The Construction of Municipal Shop Building Near Durga Hotel, Davangere

Construction of municipal shop building near Durga Mandir
Co Bangalore city Revised estimate for Rs 12,350/-
[App F 1/1 2

Subject - Construction of Municipal Shop Building near Durga Hotel at the junction of Mandipet Road in IV Ward Davanagere City sanction of the revised estimate for Rs 12,350/- received from the Municipal Engineer in this behalf

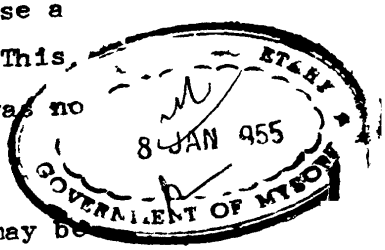
40) Designs have to be economical. Just because a slab 8" thick is put in, it cannot be approved. This, higher thickness has increased the cost. There was no need for this extra thickness.

Full details have to be furnished which may be called for. It is necessary to know whether this change was authorised.

Since a thickness of 8" is put in, the rate at the most that could be passed will be Rs 235/- per square, to compensate for this higher thickness.
